No. 671E

### Firmware Upgrade for FR-A800-AWH Inverters (FR-A800 Plus Series)

Example when Pr.351 = "9999" and Pr.353 = "9999"

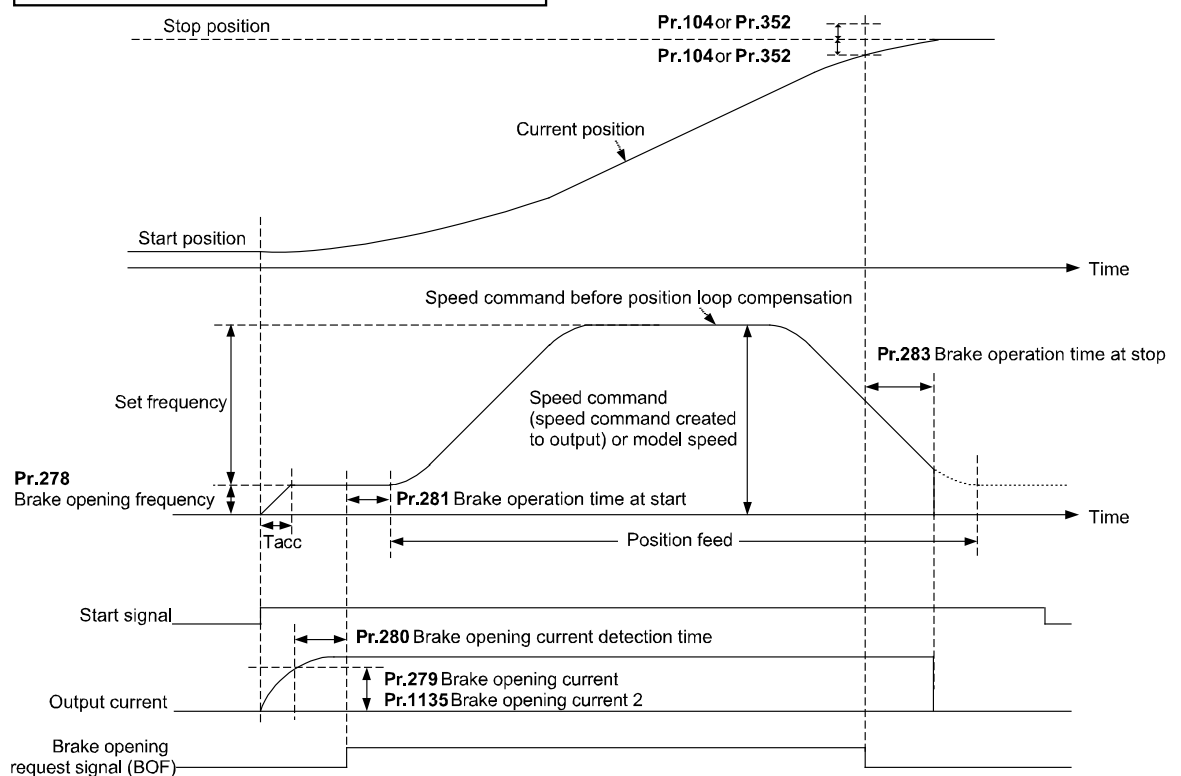
(2) Addition of second brake opening current

The brake opening current can be set individually for forward/reverse rotation (under control methods other than Vector control).

Pr.	Name	Initial value	Setting range	Description
1135 W228	Brake opening current 2	9999	0% to 400%	Set the brake opening current during reverse rotation.
			9999	Pr.279 setting value is effective.

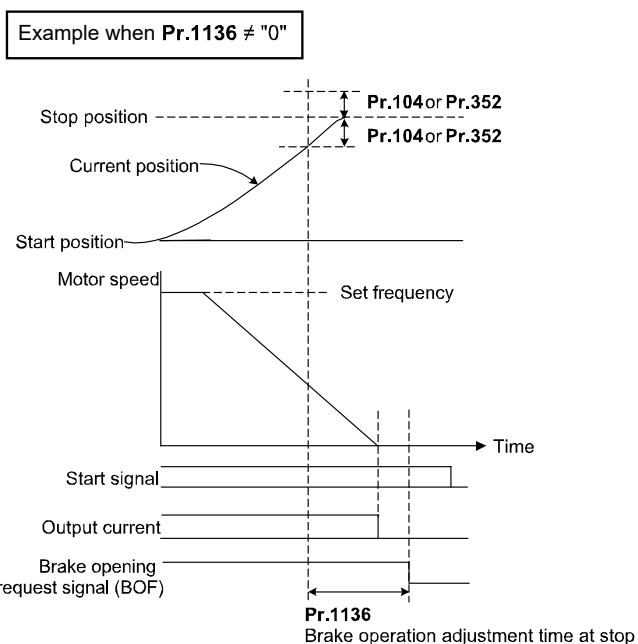
(3) Addition of brake operation adjustment time at stop

The following parameter can be used to adjust the timing of turning OFF the BOF signal (under control methods other than Vector control).

Pr.	Name	Initial value	Setting range	Description
1136 W229	Brake operation adjustment time at stop	0 s	0 to 5 s	Set the time from when the conditions to turn OFF the BOF signal are satisfied until the BOF signal is turned OFF.
